ASI No. 5 - Phase 1A Field Coordination

REFERENCE: 19121 East Wing HVAC Replacement at DelDOT Admin Bldg

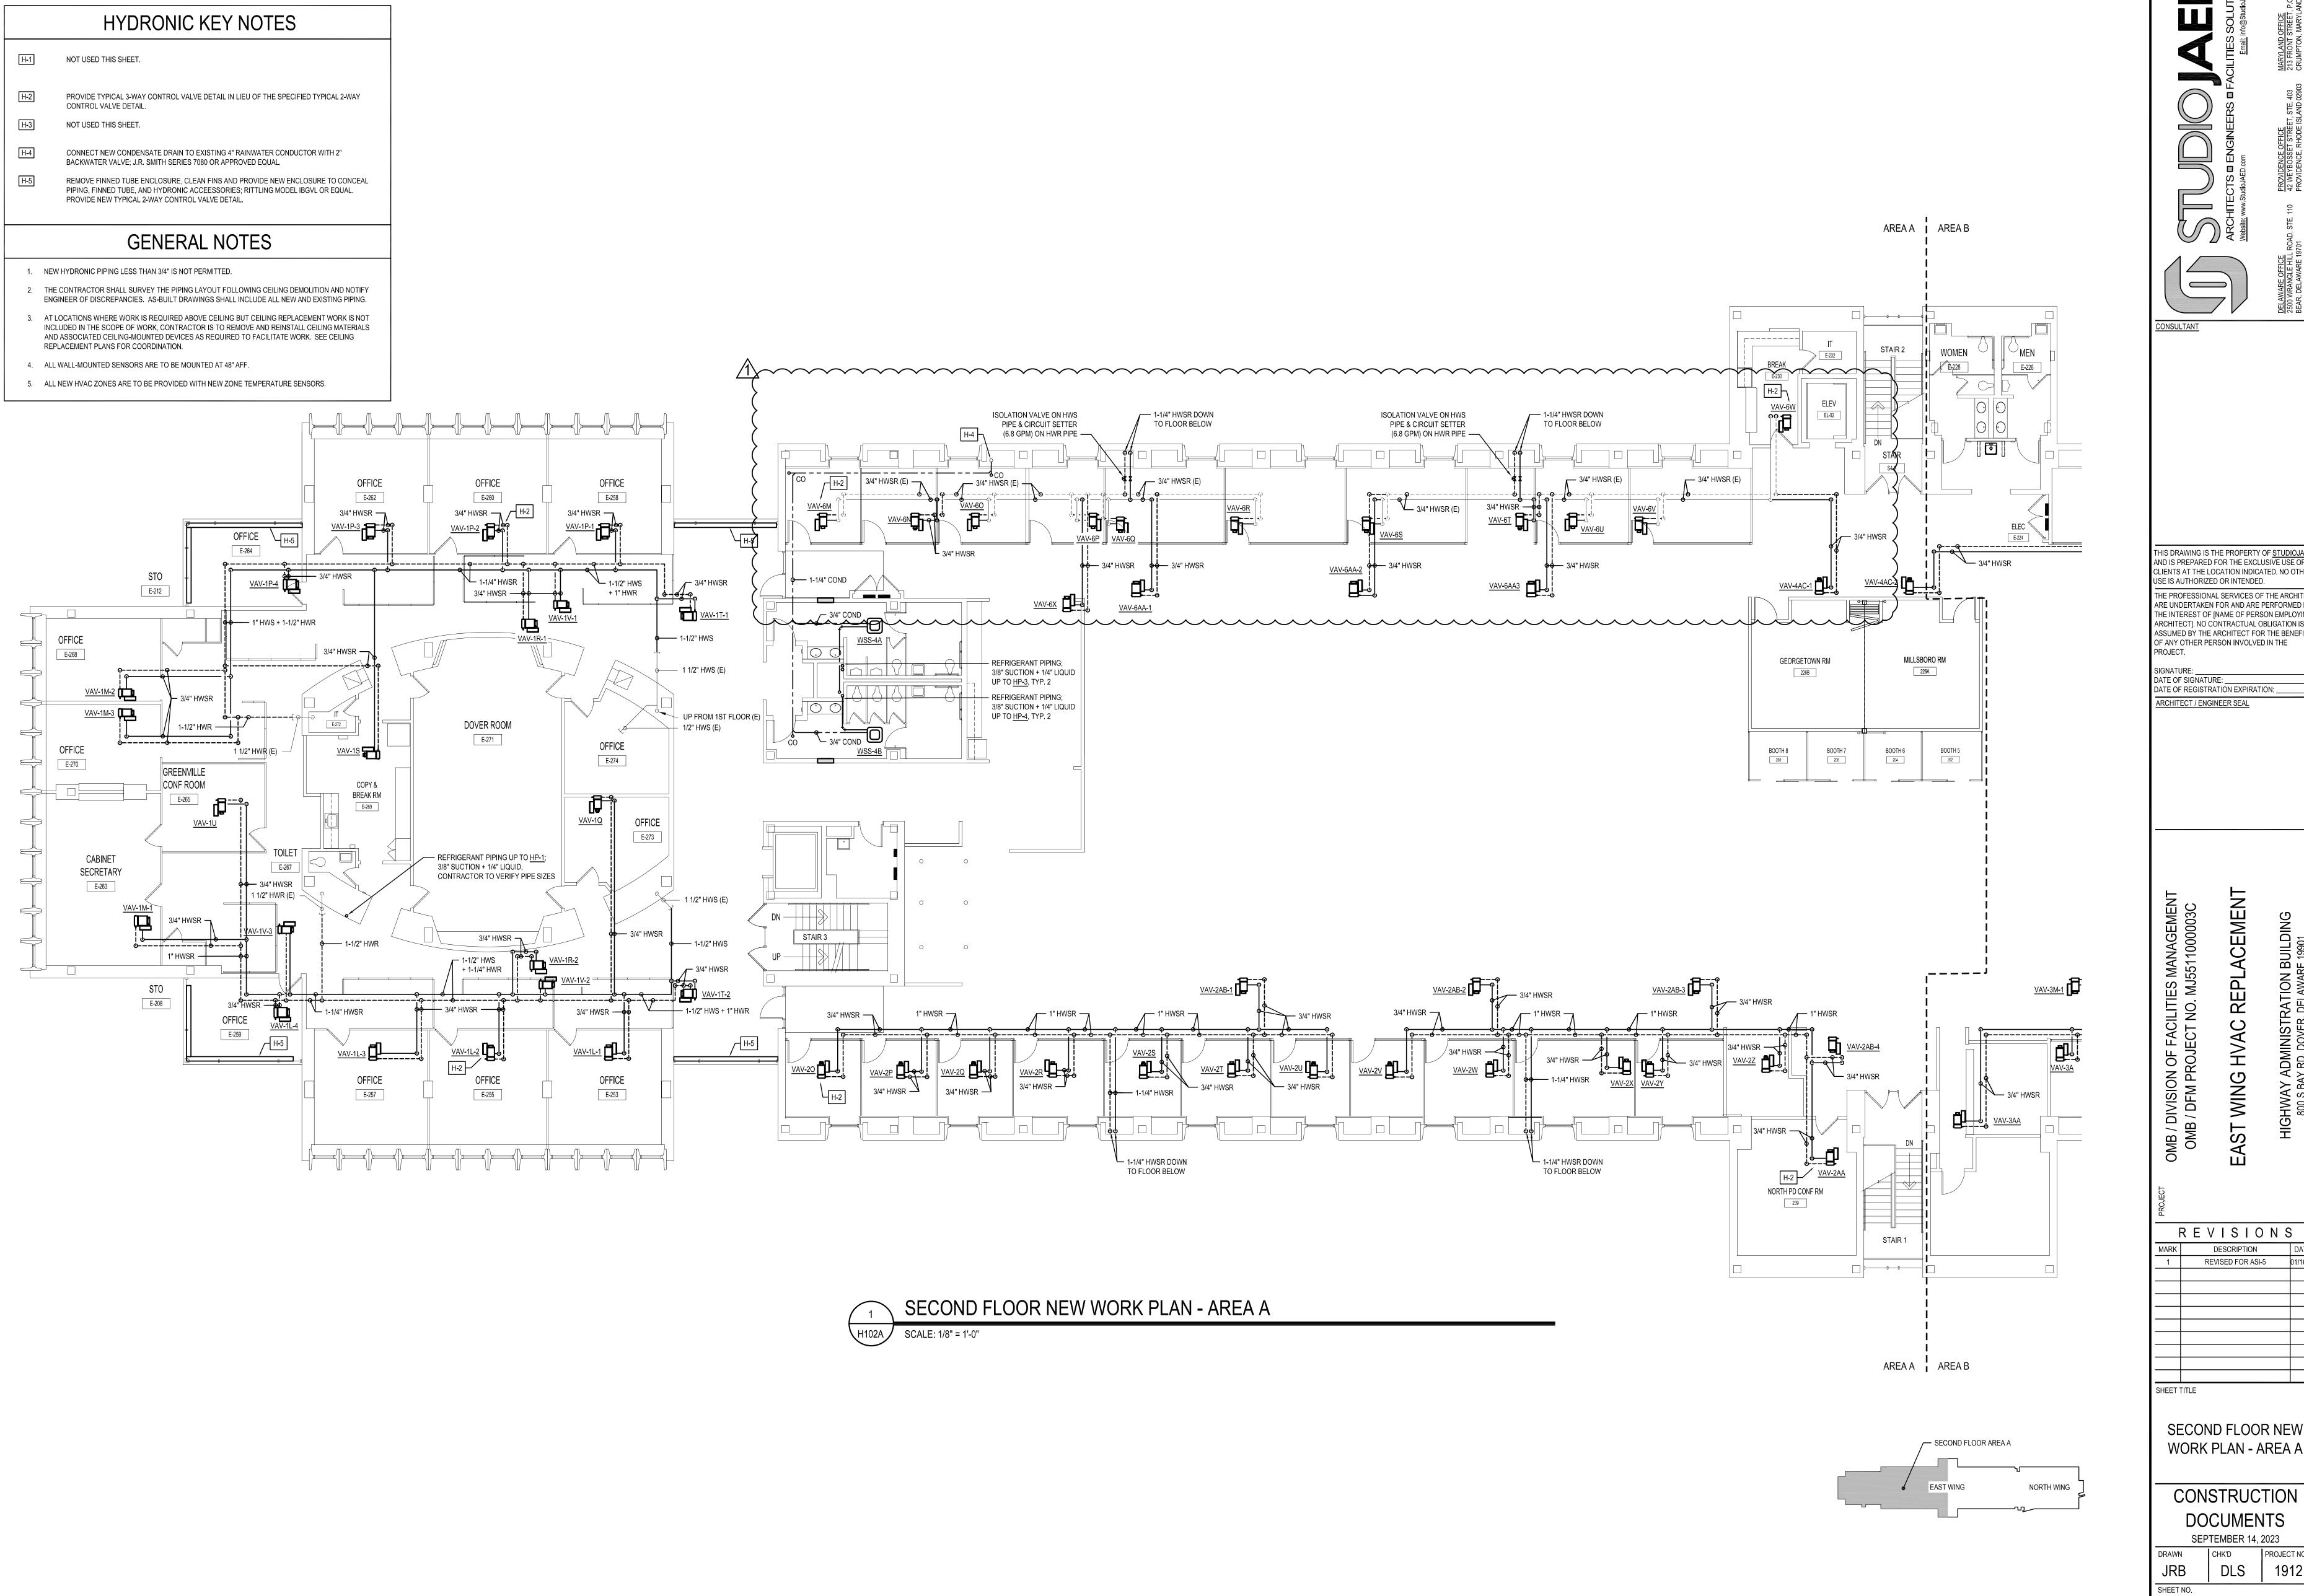
- 1. Drawing H102A:
 - a. Retain branch HWSR piping to VAV-6M, 6O, 6P, 6Q, 6R, 6S, 6U, 6V, and 6W. Contractor to verify existing pipe sizes are as indicated and runout piping to a single VAV may be reused provided it is minimum 1/2" diameter to the extent permitted by field conditions.
 - b. Proceed with new runout HWSR piping to VAV-6N, 6X, 6AA-1, 6AA-2, 6T, 6AA-3, and 4-AC-1 and revise tie-in locations as indicated.
 - c. Add isolation valve and circuit setter at each riser as indicated.
 - d. See attached, revised Drawing H102A.
- 2. Drawing H702:
 - a. Revise pipe sizes as indicated to match Drawing H102 plan.
 - b. See attached, revised Drawing H702.
